**FINAL ORDER OF  
THE VENETA PLANNING COMMISSION**

Andrew Heights Subdivision (33 Lots)

File No. S-5-22

File No. TP-23-16

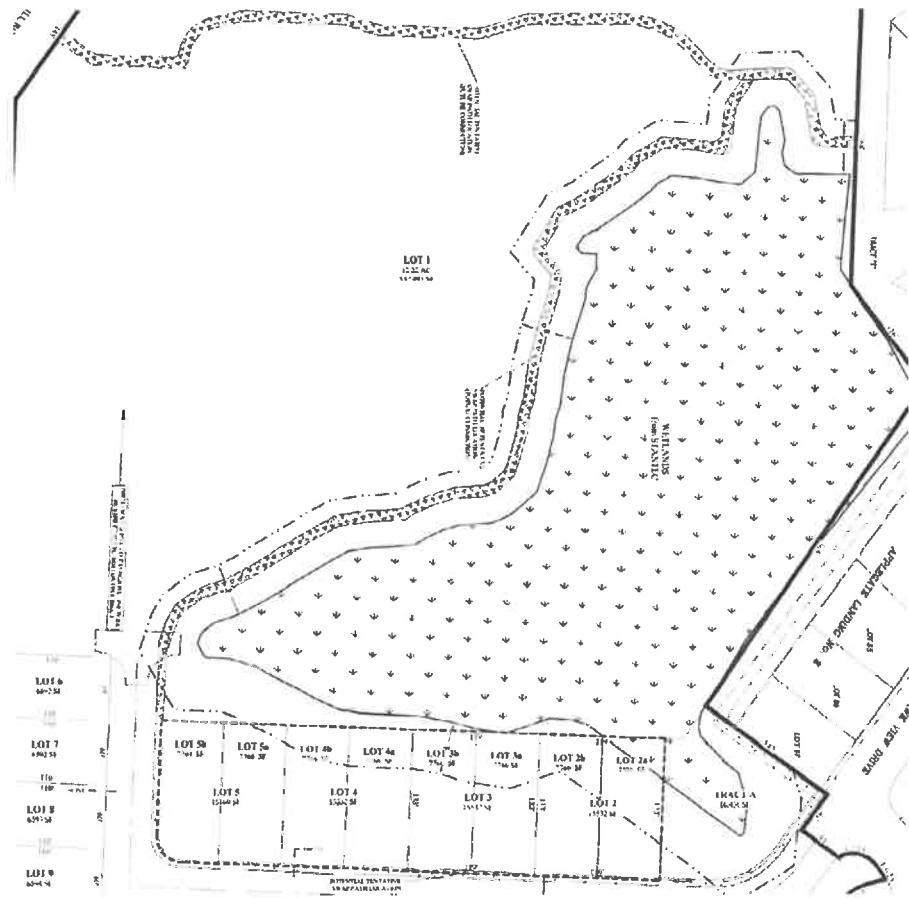
However, there are potential issues with the pedestrian and bicycle path proposed by the applicant. The SWAP indicates a separated pedestrian and bicycle path running behind what the applicant proposed to be Lots 2 through 5 and approximately circling the wetlands associated with this property, as shown in 'Figure 13 – Street and Circulation Plan' of the SWAP below:

The applicant's proposed path is not entirely consistent with the SWAP map. The location of the portion running east-west across the north end of the site is consistent with the SWAP and acceptable to staff. The portion of the path located in the Greenway, however, does not extend through the entirety of the Greenway like Figure 13 of the SWAP shows. Instead, it makes a connection to the sidewalk at the stubbed north end of Madrone Ridge Drive. Where the sidewalk fronts Lots 2-5 and Tract A, the applicant is proposing a 7-foot sidewalk rather than the typical 5-foot found elsewhere in this subdivision in lieu of having the path run through Lots 2 through 5.

As can be seen on the applicant's tentative subdivision plan above, the subdivision to the east, Applegate Landing, has a proposed path running behind the lots located east of the wetlands. This path is shown as making a connection to Hawk View Drive through Tract A. This path currently does not exist. Staff finds it necessary to require the applicant to dedicate a pedestrian and bicycle path easement in Tract A that provides for the possibility of connecting to this future Applegate Landing path, should it be built. The Paths and Trails Master Plan (PTMP) states that "A preferred easement of 30 feet wide (14 feet minimum) is recommended to allow space for trail construction and maintenance..." Since Tract A will contain the subdivision's stormwater detention pond, which constrains the available space in Tract A, the easement can be reduced to a minimum of 14 feet rather than the typical 30 feet.

**Condition of Approval:** The applicant shall show on their public improvement plans the location of all pedestrian and bicycle paths as approved by the Planning Commission.

**Optional Condition of Approval:** Prior to construction, the applicant must submit a revised tentative subdivision plan showing a 10-foot wide pedestrian and bicycle path in the Greenway Open Space Subzone surrounding the wetlands on the site. The path must begin at the northeastern edge of the Greenway and continue through the Greenway until it makes a connection to Hawk View Drive through Tract A.

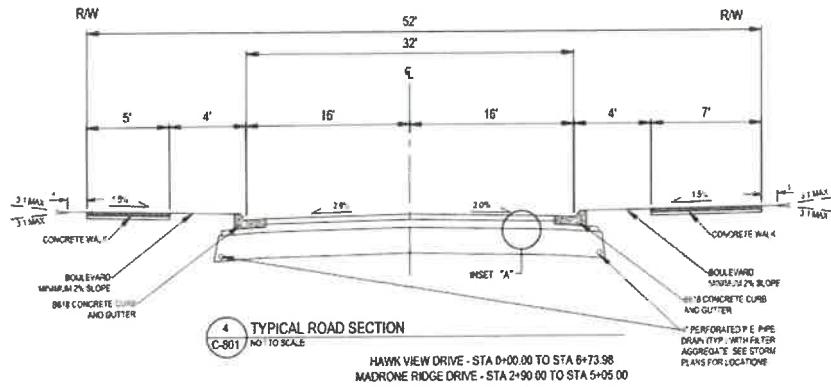
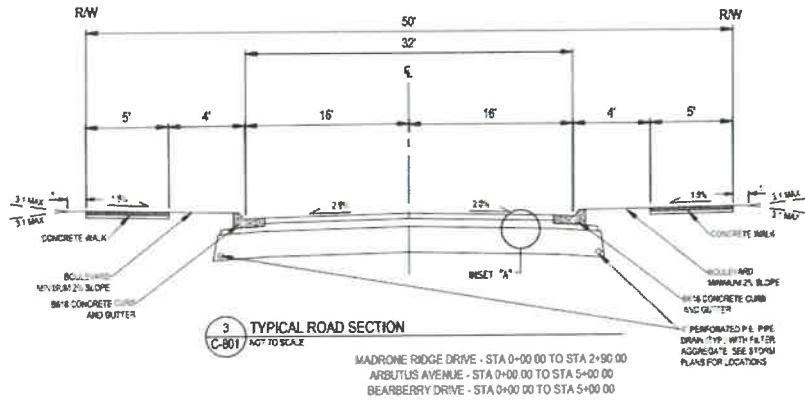
The proposed sidewalks meet the 5' minimum. The paved roadway meets the 32' minimum. The planter strip in the applicant's proposed street section is stated to be 4' wide, but is effectively 3.5' wide, as 6" is being used for the curb. The SWAP street cross section, however, shows a 4' wide planter strip.

feet, bringing the total right-of-way width to 52 feet. If the Planning Commission determines that the pedestrian and bicycle path should continue through the Greenway rather than connecting to Madrone Ridge Drive, this 7-foot sidewalk width would be unnecessary, and the sidewalk width can be reduced to 5 feet.

**Conclusion:** A condition of approval requiring the applicant submit a revised street cross section showing the 6-inch curb located within the paved roadway width rather than the planter strip is necessary in order to ensure compliance with this standard.

**Condition of Approval:** Prior to any construction on the site, the applicant must submit a revised right-of-way street section (utility plan Sheet C-801). The revised street section will be required to include a 4-foot planter strip on each end. The revised street section must show the 6-inch curb located within the 32-foot paved roadway width on each end. Public improvement plans shall be consistent with the standards laid out in this condition.

FIGURE 15. PROPOSED NETWORK- SOUTHWEST QUADRANT

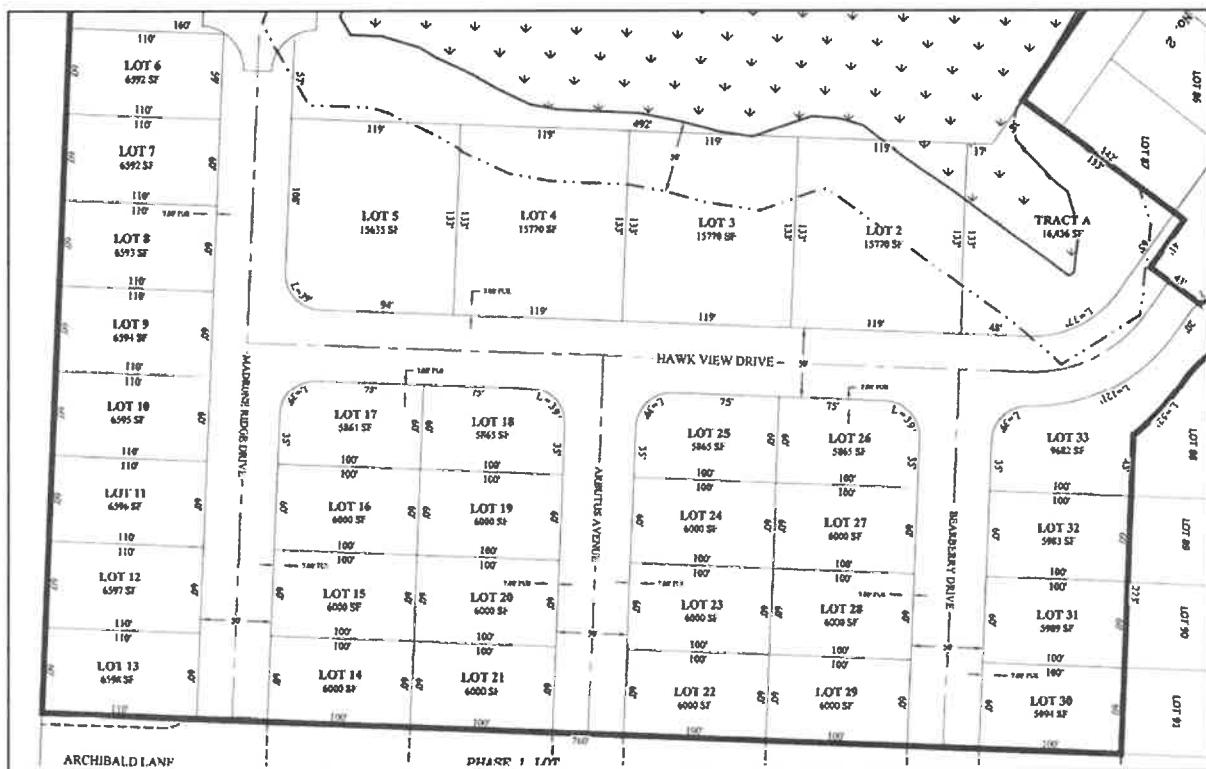
Additionally, 'Figure 15 – Proposed Network – Southeast Quadrant' of the Parks and Trails Master

Plan shows a separated pedestrian and bicycle path circling the wetlands identified on the site and making a connection to Hawk View Drive at the location of the proposed Tract A. The applicant's proposal is inconsistent with the path laid out in the Parks and Trails Master Plan. Figure 15 of the PTMP is shown below:
